BELFORD AVENUE OVER HAPPY CANYON CREEK  
72'30"00" SKEW (TO LAYOUT LINE)  
74'-0" ROADWAY WIDTH, EDGE OF SIDEWALK  
TO EDGE OF SIDEWALK (ULTIMATE)  
8'-6" SIDEWALKS

Print Date: 11/18/2016 8:09:49 AM	Sheet Revisions				As Constructed	BELFORD-HAPPY CANYON CREEK BRIDGE		Project No./Code
File Name: B115360-01INF01.dwg	Date	Comments	Initials		No Revisions:	GENERAL INFORMATION		
Horizontal Scale: VARIES Vertical Scale:				Revised:	Designer: J. LYNCH	Structure Numbers		
				Void:	Detailer: C. MIYAMOTO			
6300 South Syracuse Way, Suite 600 Centennial, CO 80111 tel 303.721.1440 fax 303.721.0832					Subset: BRIDGE	Sheets: B1 of 32		Sheet Number 11

**BELFORD-HAPPY CANYON CREEK BRIDGE**  
**SUMMARY OF QUANTITIES**

As Constructed	BELFORD-HAPPY CANYON CREEK BRIDGE PILING & CAISSON DETAILS		Project No./Code
No Revisions:	Designer: J. LYNCH	Structure Numbers	
Revised:	Detailer: C. MIYAMOTO		
Void:	Subset: BRIDGE	Sheets: B11 of 32	Sheet Number 21

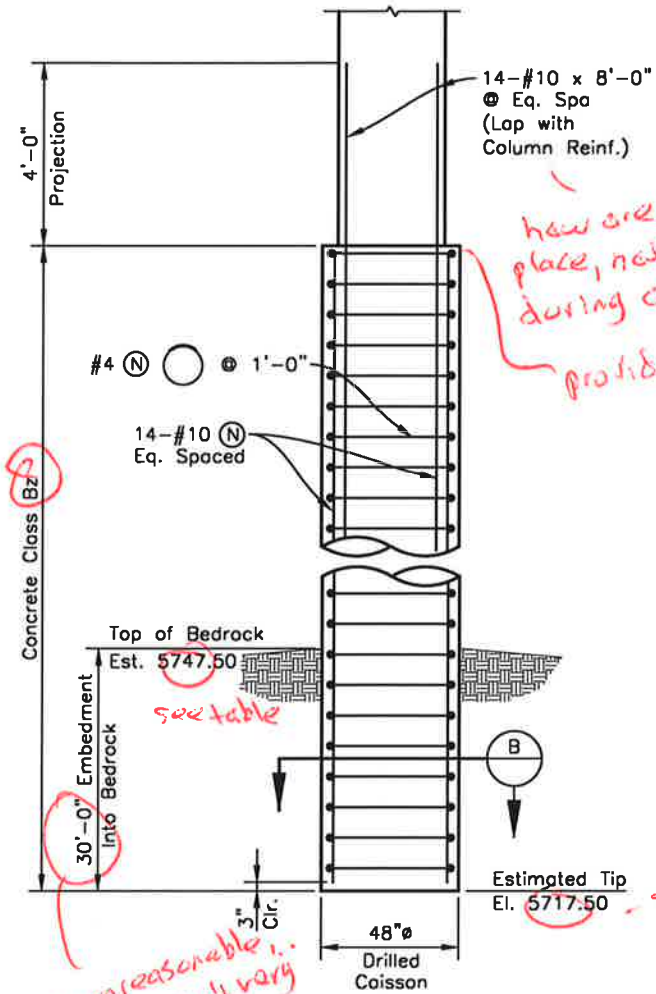
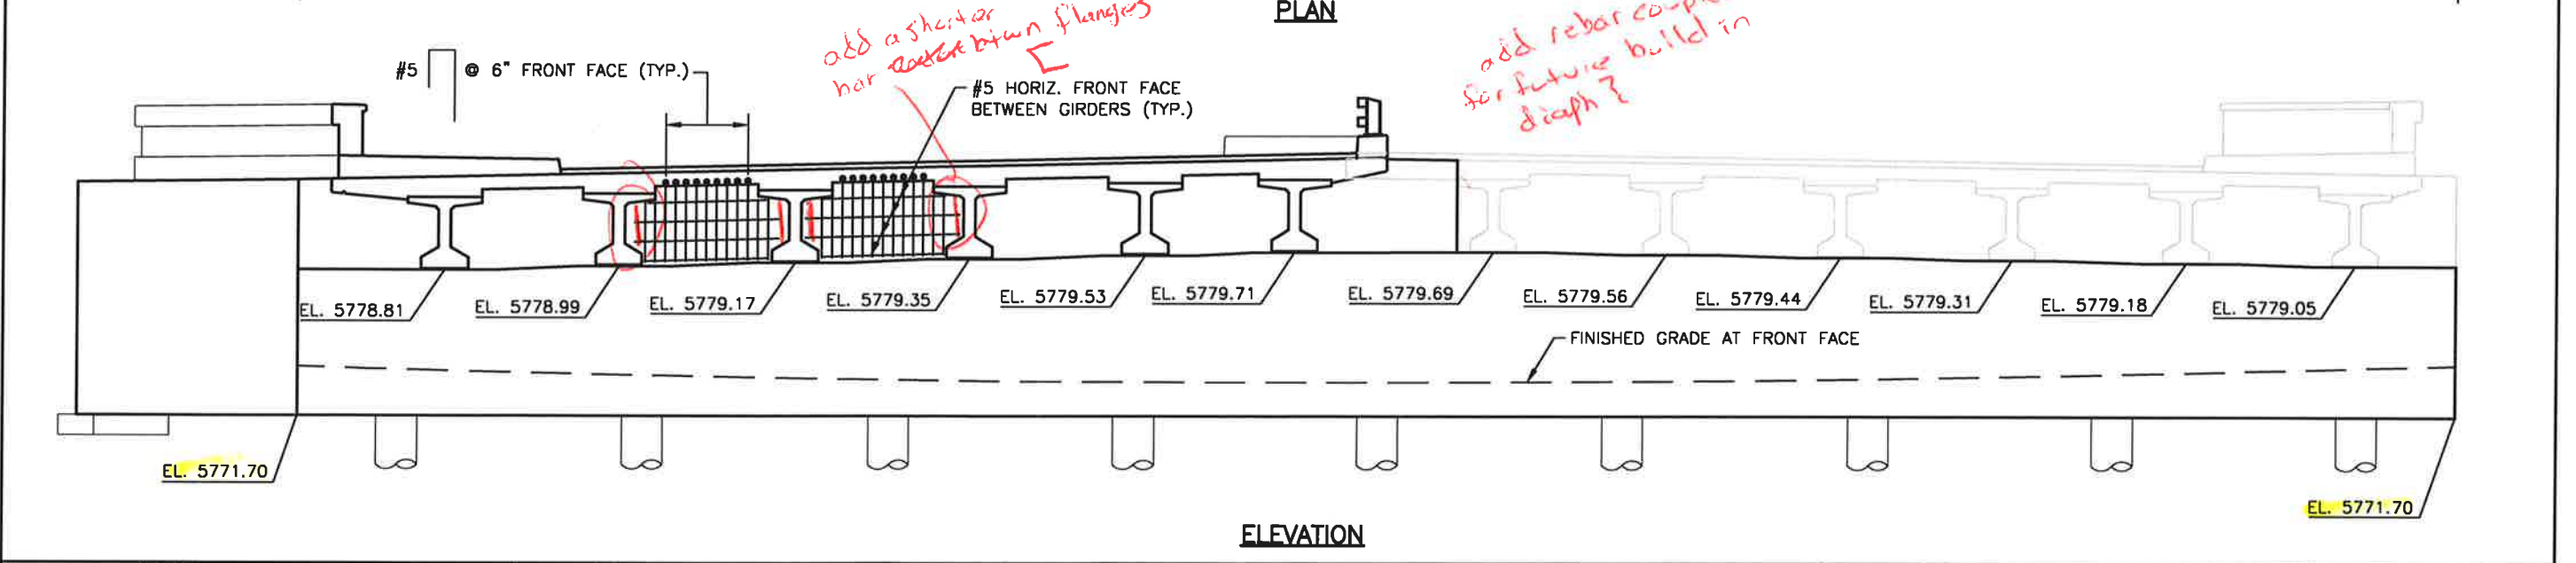
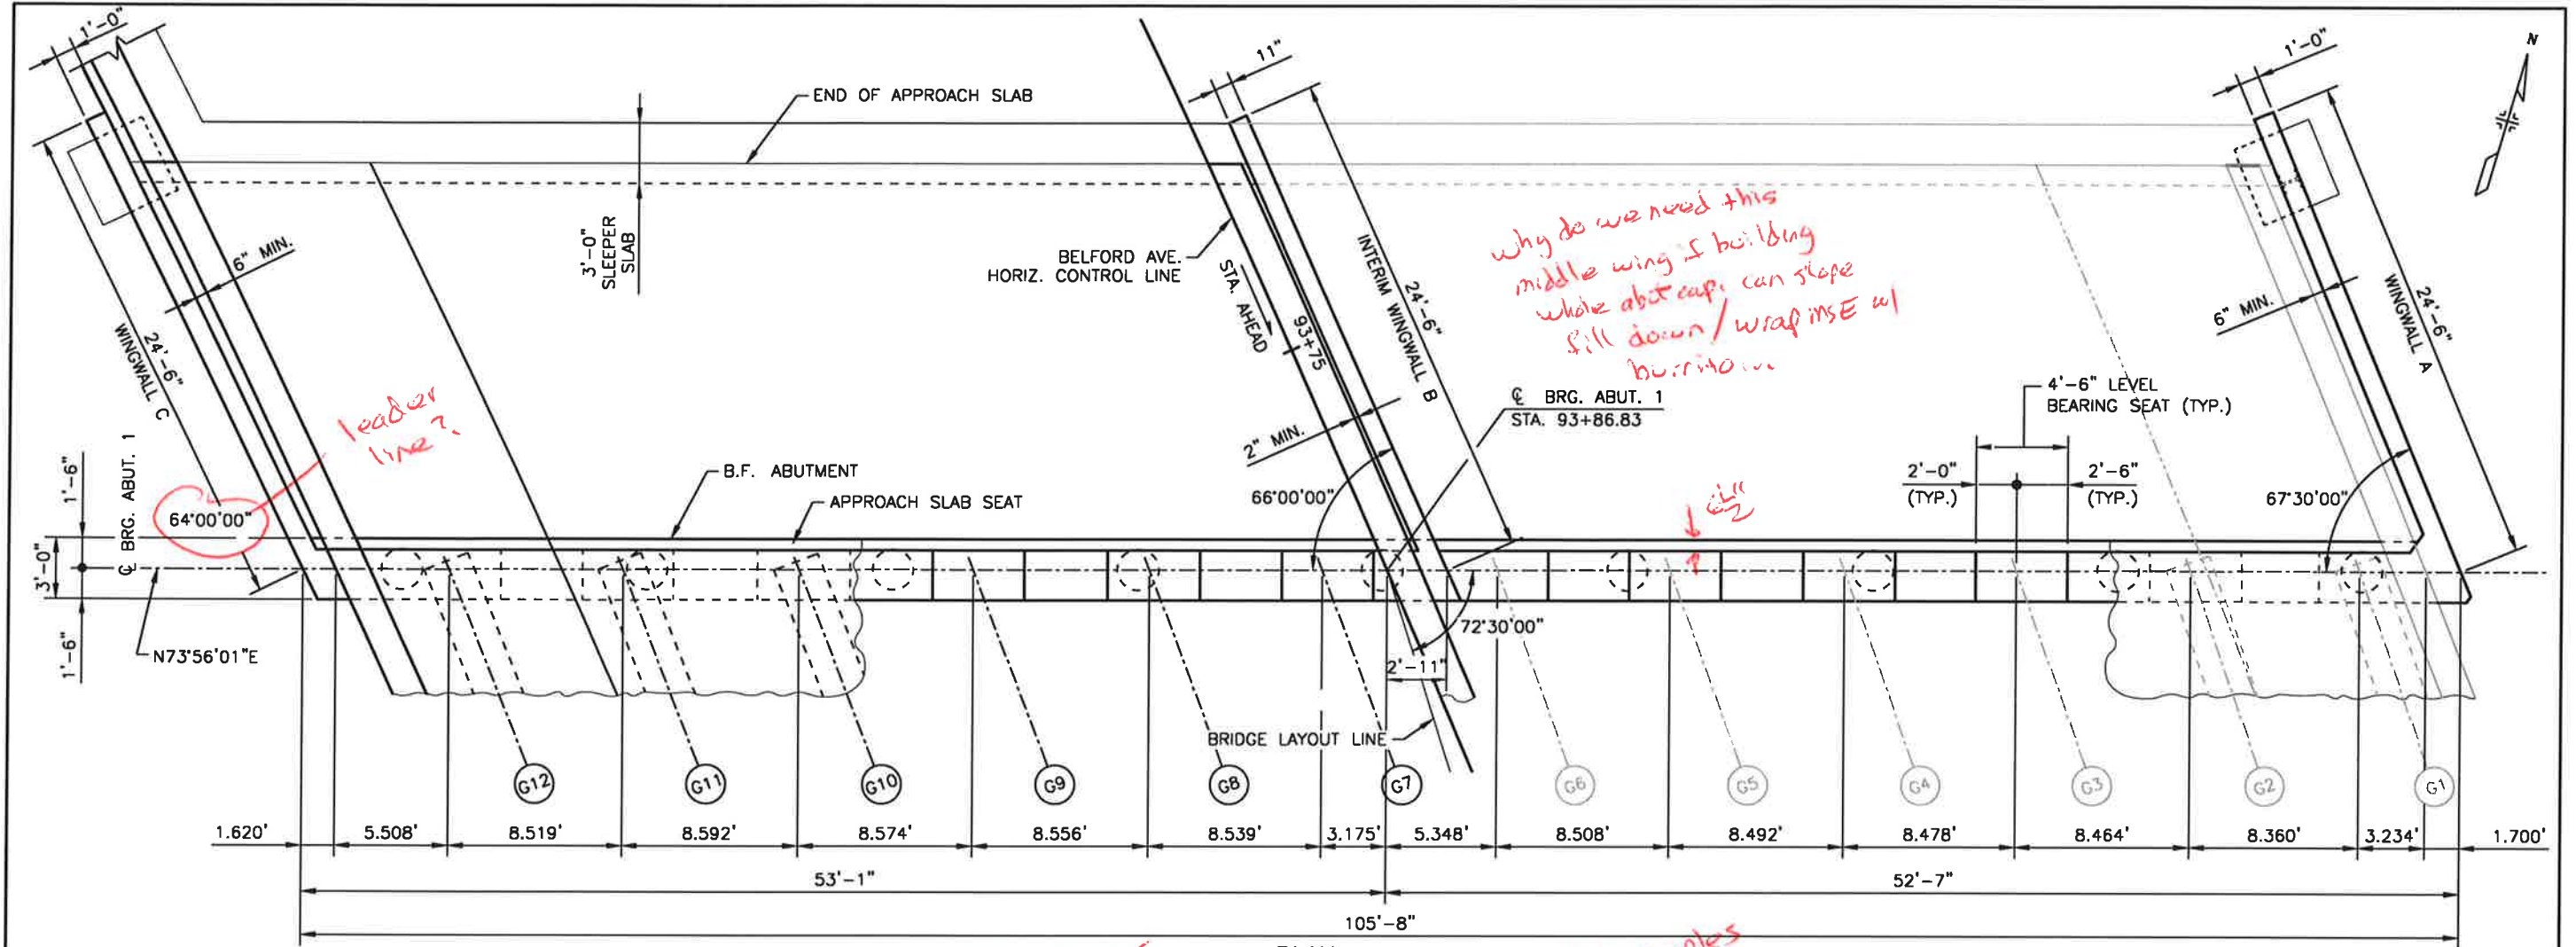
how are these held in place, nothing to tie to during caisson pour? provide header caisson entable. El 5764.0 Bedrock or hard bedrock? be consistent & match Geotech report.

Pier 2?

Service form this is LRFD...

Seems unreasonable... but rock isn't vary hard looking as blow counts.

why don't laps = ?

mag? in a stream...

min pier L per geotech is 40' ... only have 34 & 38...

As Constructed	BELFORD-HAPPY CANYON CREEK BRIDGE ABUTMENT SECTIONS & DETAILS		Project No./Code
No Revisions:	Designer: J. LYNCH	Structure Numbers	
Revised:	Detailer: C. MIYAMOTO		
Void:	Subset: BRIDGE	Sheets: B14 of 32	Sheet Number 24

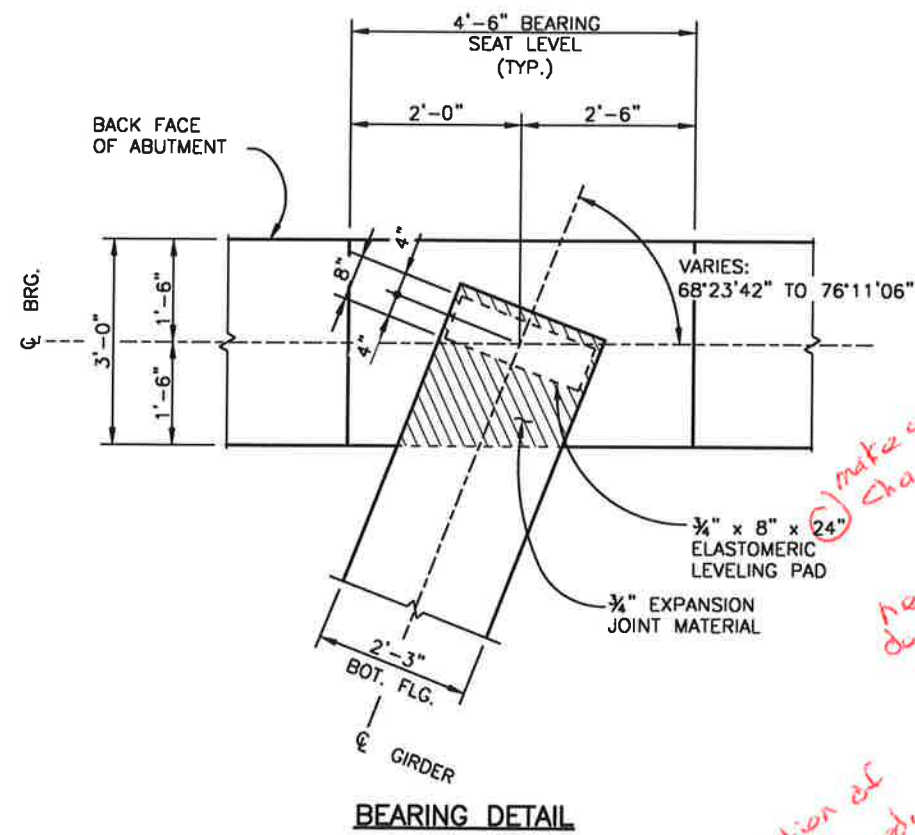
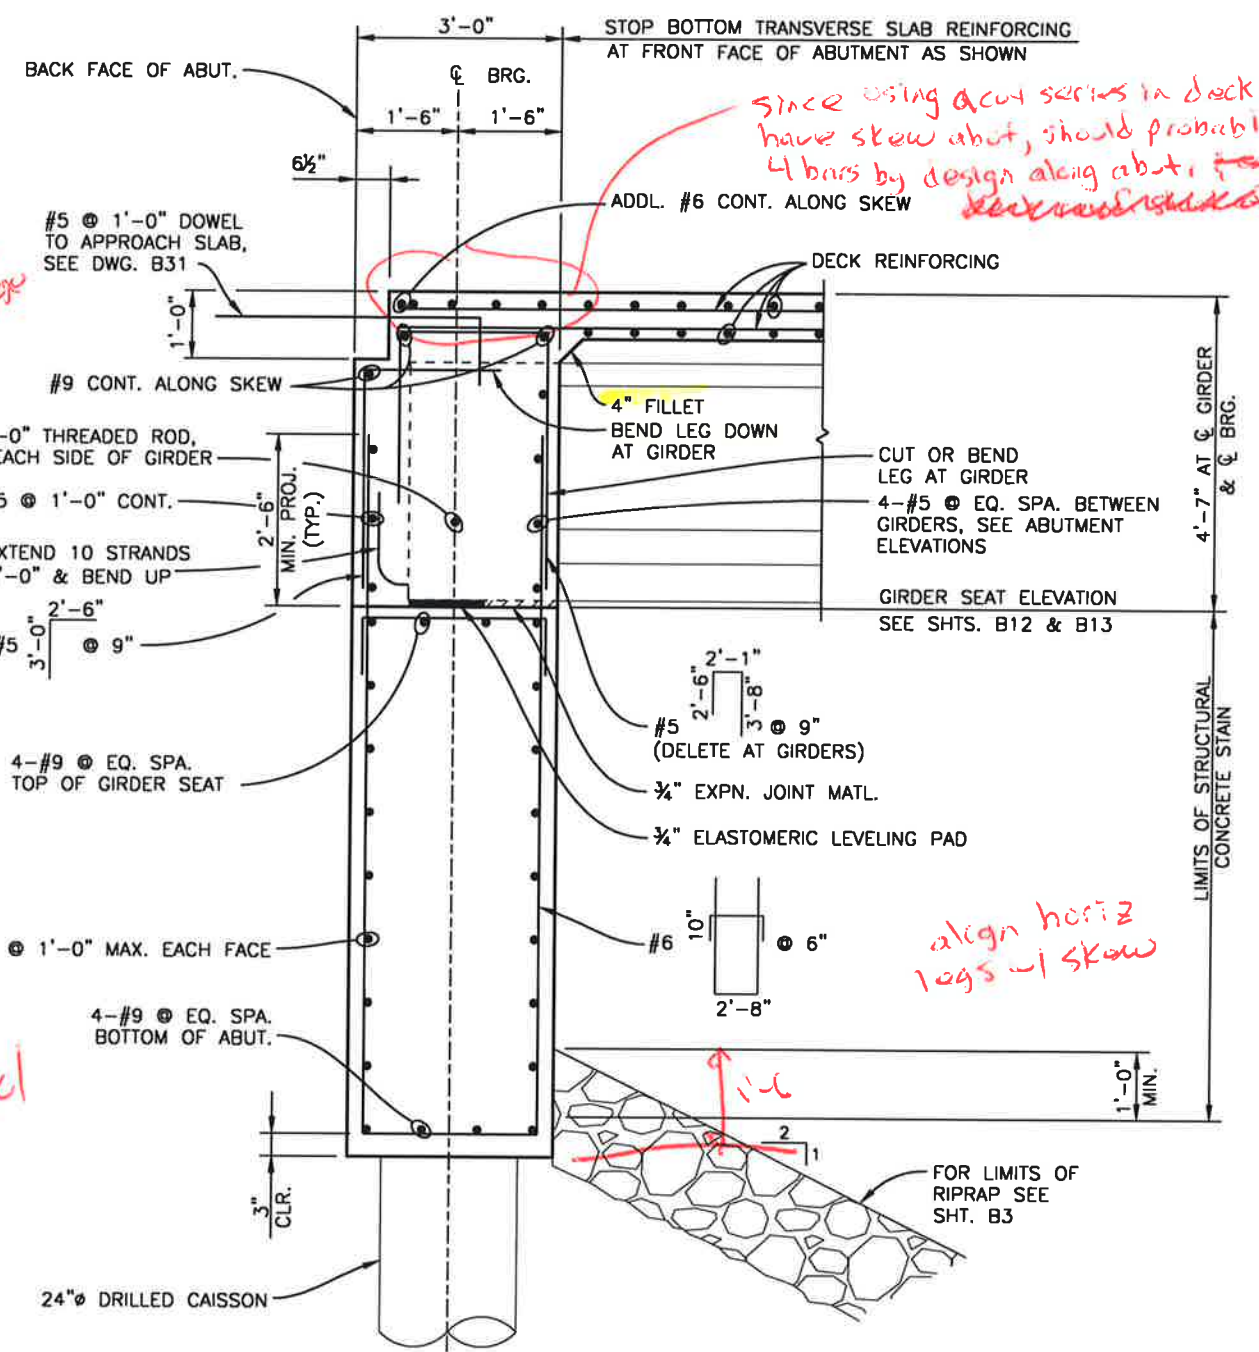
*COOT prefers a pin connection of super to sub. This is fully fixed. How did the designer account for the moment girders will develop and did they account for moment in caisson design*

*make width to start of chamfers on bot flange = 2'-2\"*

*need to be bent due to skew*

*OK to let vert rebar stick up in future position? Aesthetic/safety issue...*

*since using acut series in deck and have skew abut, should probably have 4 bars by design along abut. ~~from design~~*

*align horiz legs w/ skew*

As Constructed	BELFORD-HAPPY CANYON CREEK BRIDGE WINGWALL DETAILS		Project No./Code
No Revisions:	Designer: J. LYNCH	Structure Numbers	
Revised:	Detailer: C. MIYAMOTO		
Void:	Subset: BRIDGE	Sheets: B15 of 32	Sheet Number 25

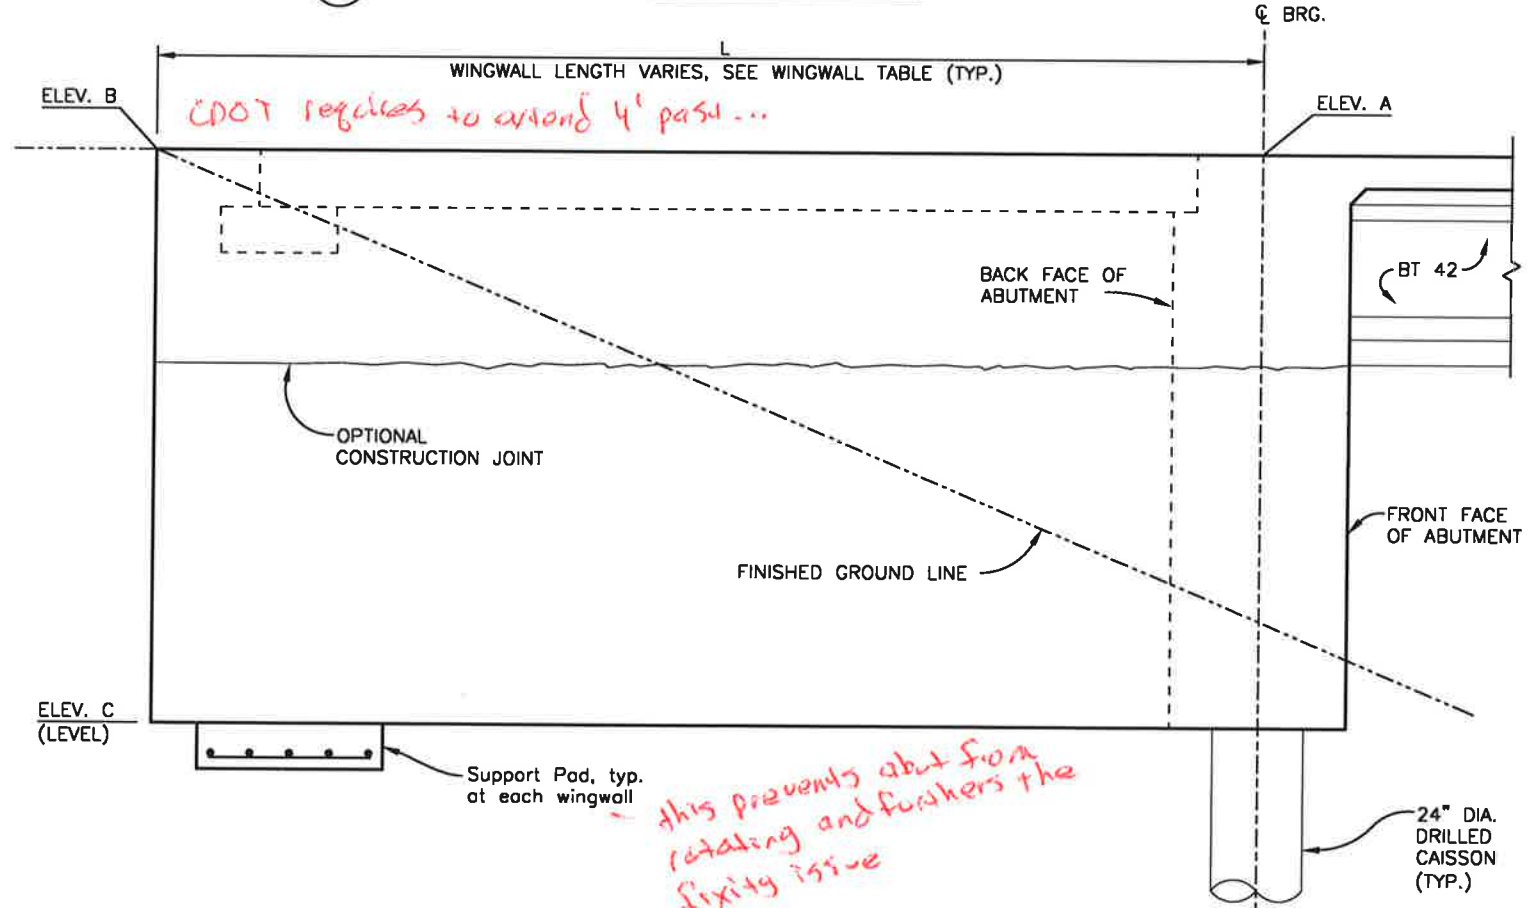
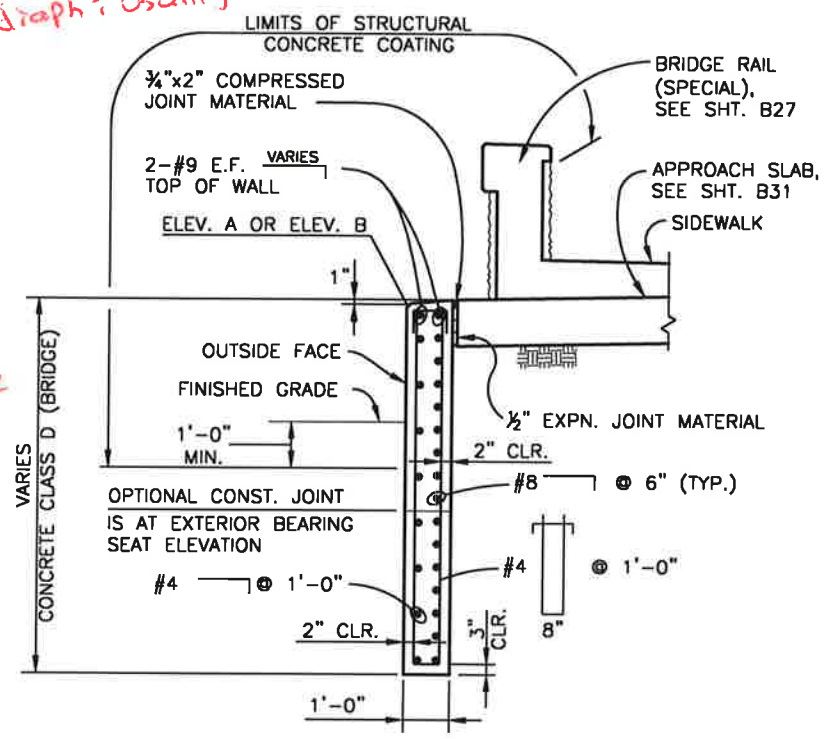
*any interference w/ gdr in diaph? usually is...*

*chamber size*
